# Access Compliance Report

## Public Rights-of-Way

### (Curb Ramps)

Intersection ID: 46816	Main Street: CYPRESS_VIEW_DR	Cross Street: ARBOR_VISTA_DR	Location: NE
ADA ID: 826E560CB070	Ramp Type: PerpDiag	Initial Pass/Fail: Fail	Overall Compliance: No
Severity Score: 46.25			
Codes/Mitigation Info/Possible Solution		Field Measurements/Component Compliance

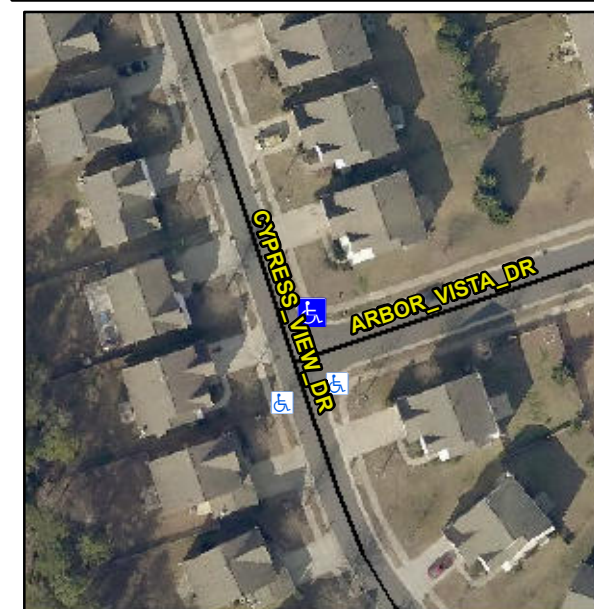
**R304.5.1, R304.2.2, R304.5.3**

Compliance	Description	Data	Compliance	Description	Data
N/A	Ramp Length (in)	46.5	No	Ramp Slope (%)	13.3
No	Ramp Width (in)	45.5	No	Ramp XSlope (%)	6.1
N/A	Flare Type LT	N/A	N/A	Flare Type RT	N/A
N/A	Flare Slope LT (%)	N/A	N/A	Flare Slope RT (%)	N/A
N/A	Flare Traversable LT?	N/A	N/A	Flare Traversable RT?	N/A
N/A	Landing Length (in)	N/A	N/A	DWS Provided?	N/A
N/A	Landing Width (in)	N/A	N/A	DWS Contrast?	N/A
N/A	Landing Slope (%)	N/A	N/A	DWS Length (in)	N/A
N/A	Landing X Slope (%)	N/A	N/A	DWS Full Width?	N/A
N/A	Landing Curb? (Y/N)	N/A	N/A	DWS Offset (in)	N/A
N/A	Shared Landing?	N/A			
N/A	Gutter Ponding?	N/A	N/A	Gutter Slope (%)	N/A
N/A	Gutter Lip Ht (in)	N/A	N/A	Gutter X Slope (%)	N/A
N/A	Painted X Walk1?	No	N/A	Painted X Walk2?	No
	X Walk 1 Direction	To W		X Walk 2 Direction	To S
N/A	X Walk 1 Width (in)	N/A	N/A	X Walk 2 Width (in)	N/A
	X Walk 1 Slope (%)	5.9		X Walk 2 Slope (%)	1.5
	X Walk 1 X Slope (%)	3.5		X Walk 2 X Slope (%)	5.2

**Remove & Replace Curb Ramp With Two New Directional Ramps or Equivalent.**
